## AGENDA ITEM SUMMARY REPORT

**APPLICATION NO.:** CDP 8-19, DR 1-19, MGR 1-19

**PROJECT:** A Coastal Development Permit, Design Review and Notice of Merger to construct a Grocery Outlet Market (retail store). The project includes the demolition of an existing 16,436-square-foot vacant former office building and associated 47-space parking lot and wooden fencing along the property line, and the construction and operation of a 16,157-square-foot, one-story, retail store with a 53-space parking lot and associated improvements and infrastructure. The project would be operated by 15 to 25 full-time staff and two (2) managers and would be open from 9:00 AM to 10:00 PM, 7 days per week with two (2) different shifts covering operating hours.

Figure 1, Map Case No 2, Drawer 37 Page 79 parcel "A" dedication.

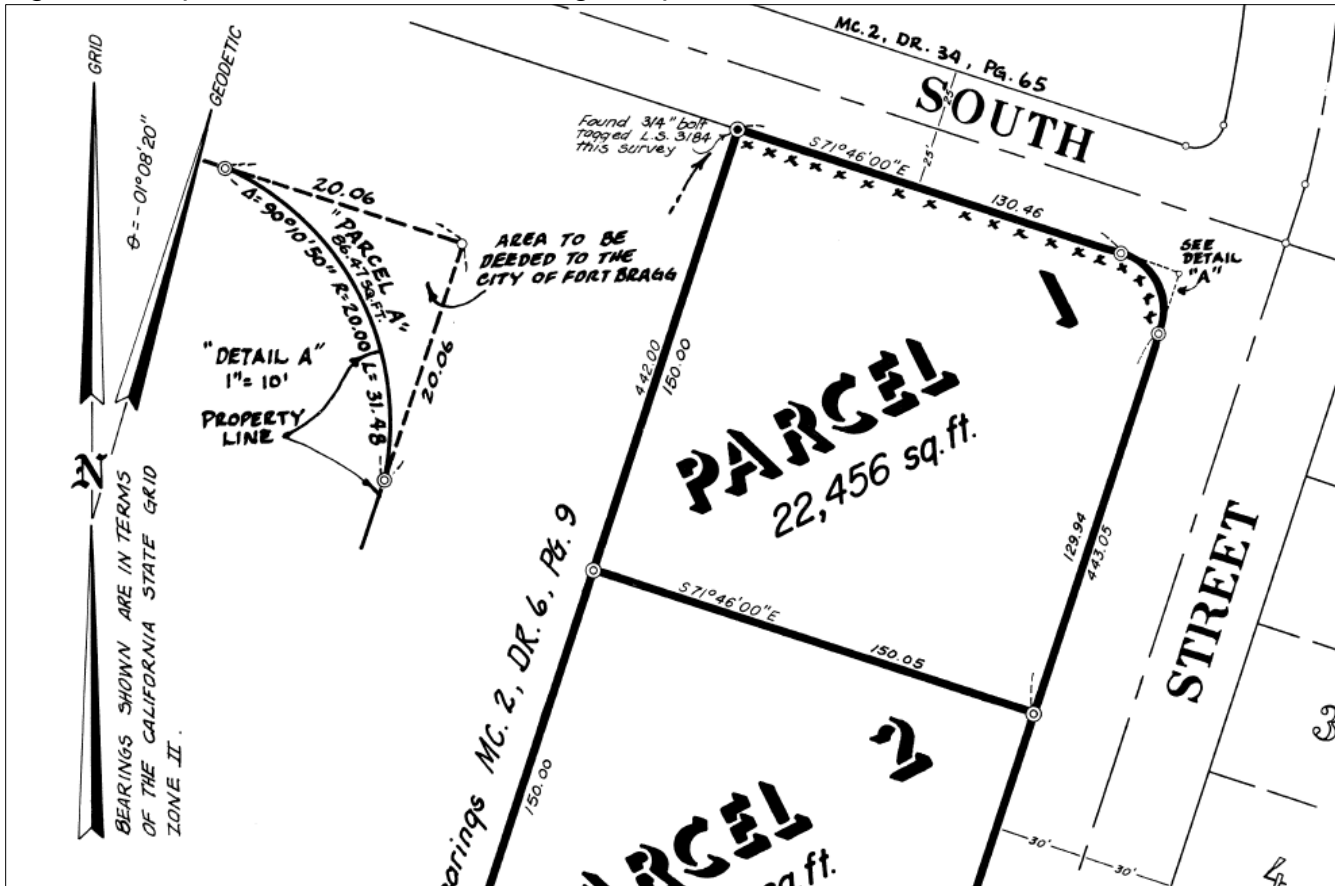
As required in previous parcel subdivision, the Parcel A identified in the Parcel Map recorded on April 14, 1981 and located in Map Case 2 Drawer 37 Page 79 shall be dedicated to the City to fulfill previous commitments. The three (3) parcels that make up the project site were subdivided and recorded on April 14, 1981 (**figure 1**). According to the map, the 86.47 square-foot triangle at the northeast corner of the parcel at the intersection of South Street and South Franklin Street identified as Parcel "A", was to be dedicated to the City of Fort Bragg. However, there are no records to indicate that the dedication was ever completed. **Special Condition 10** is recommended to require that, as part of the merger, the applicant complete the previous

subdivision requirement to dedicate Parcel "A" as identified and recorded on April 14, 1981 and located at the City of Fort Bragg in Map Case 2 Drawer 37 Page 79, under reference number 5356.
